**Public Service Company of Colorado**  
5909 East 38th Avenue, Denver, Colorado, 80207

June 7, 1982  
Fort St. Vrain  
Unit No. 1  
P-82184

Subject: Electrical Power Systems

Documentation of Voltage Studies

FIGURE 5 - GRID VOLTAGE AT LOWEST EXPECTED VALUE 226KV CONCURRENT WITH STARTING OF BFP. BASE VOLTAGE = 480V

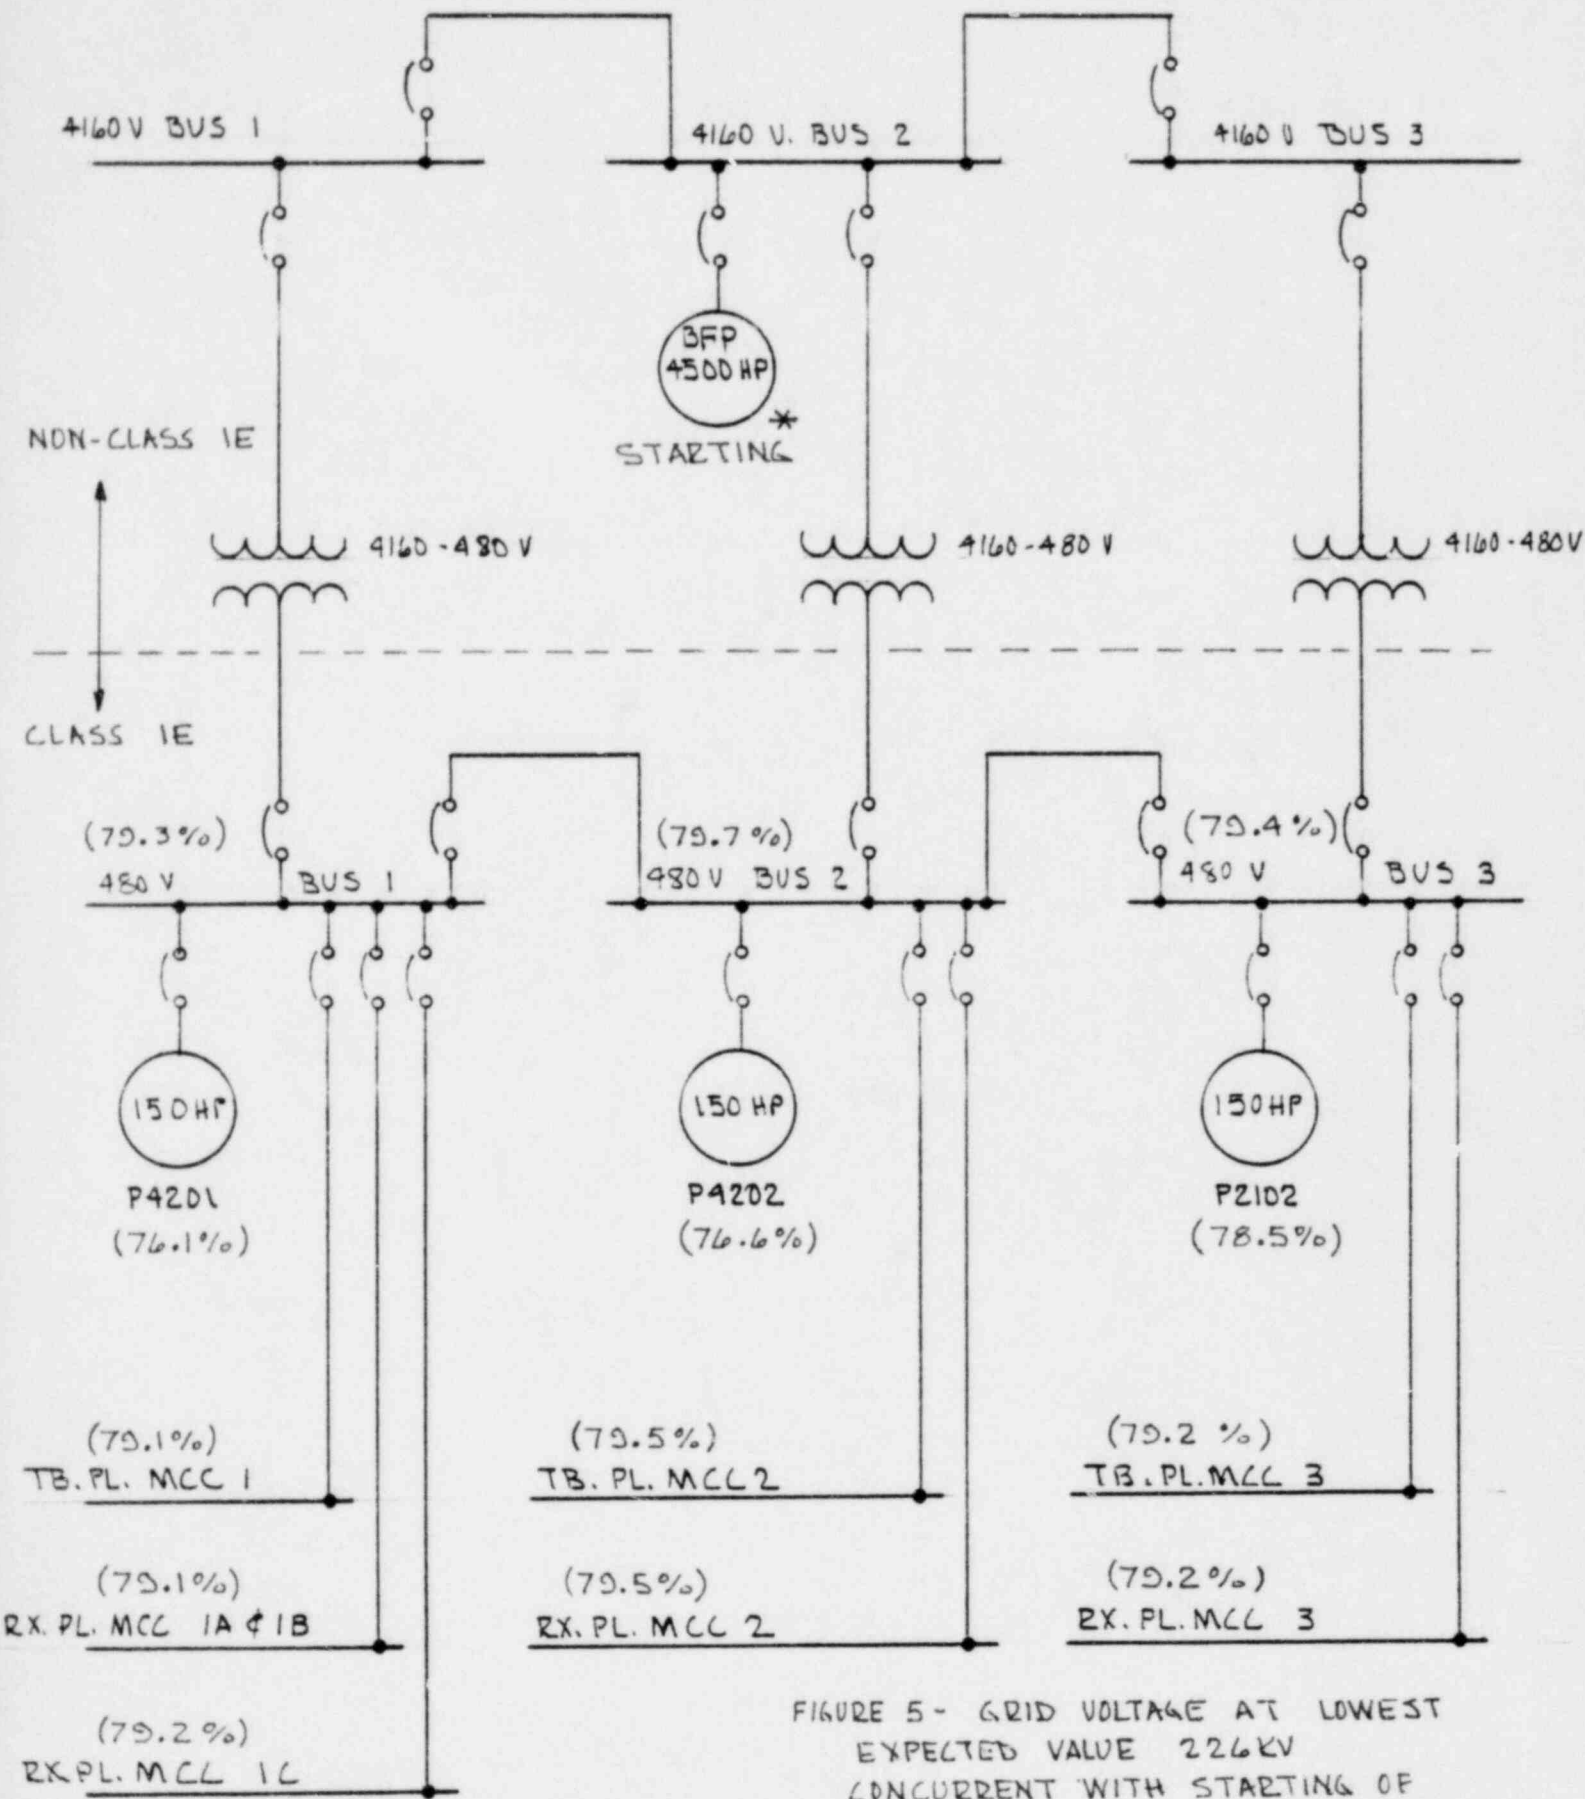
ITEM 1 - ATTACHMENT 2, Page 2 - Analytical Verification of the Capabilities of the Fort St. Vrain Distribution system When Powered from Offsite Sources:

Figures 5 and 6 provide data from the analytical studies for the high and low voltage situations.

ITEM 4 - ATTACHMENT 2 Page 6

The voltage analysis should include documentation for each condition analyzed of the voltage at the input and output of each transformer and at each intermediate bus between the connection to the offsite circuit and the terminals of each safety load.

For the low grid voltage case the manual starting of the 4500 HP Boiler Feedpump was assumed. Approximately the same loads will be in service regardless of whether the proposed start occurs during routine plant startup or if the start occurs following a unit trip.

Figures 5 and 6 provide this information for the safety-related buses. High and low voltage situations are presented.

Low Voltage Case

No equipment will be damaged or will fail to operate as a result of this hypothetical situation.
